ENGINEERING REPORT

DA#:	SA 2020 / 0009
Applicant:	Nick Griggs & Co
Proposal:	Subdivision (11 lots)
Address:	66 Alma Road, Orford
Zone:	Low Density Residential
Report completed by (Name & date):	Leigh Wighton 14 August 2020

Figure 7.7 1pct 4.5hr Climate Change Low Density Residential model results. Max Water Depth. Map showing all depths for comparison.

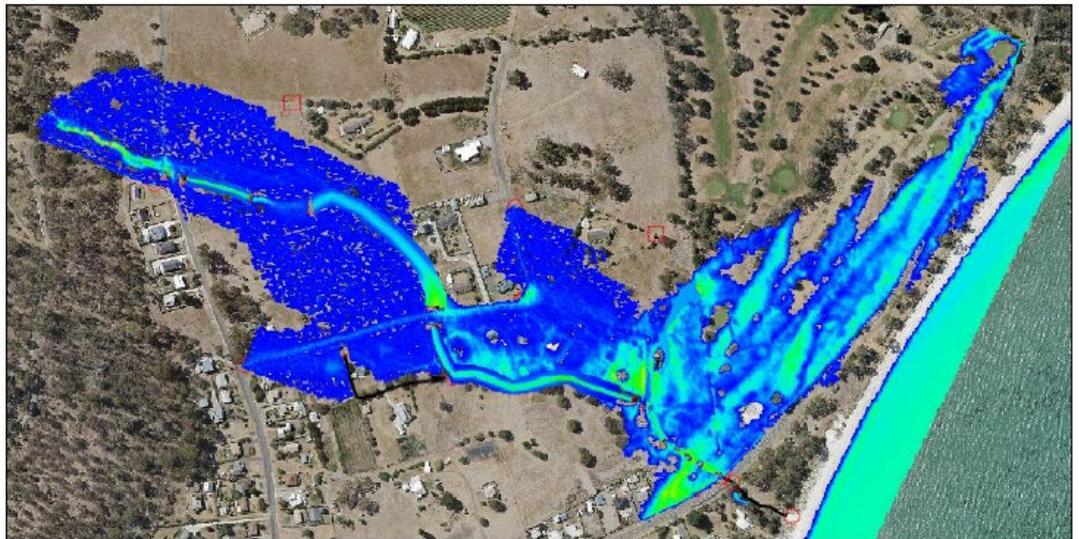
The proposal does not meet the acceptable solution, being:

Each lot, or a lot proposed in a plan of subdivision, within a Riverine Inundation Hazard Area must:

- (a) be able to contain a building area, vehicular access and services, that are wholly located outside a Riverine Inundation Hazard Area;

In order to address the risk a condition requiring the developer to provide a Flood Hazard Report, prepared in accordance with section E15.0 Inundation Prone Areas Code of the Planning Scheme for approval by Councils General Manager. Once approved the Report will form part of the endorsed documents.

Any measures required by the report to ensure that a tolerable risk for the development from flooding is achieved and there is no increase in risk from flood for adjacent land must be included in the engineering design drawings and implemented prior to the sealing of the Plan of Survey for any stage of the subdivision.
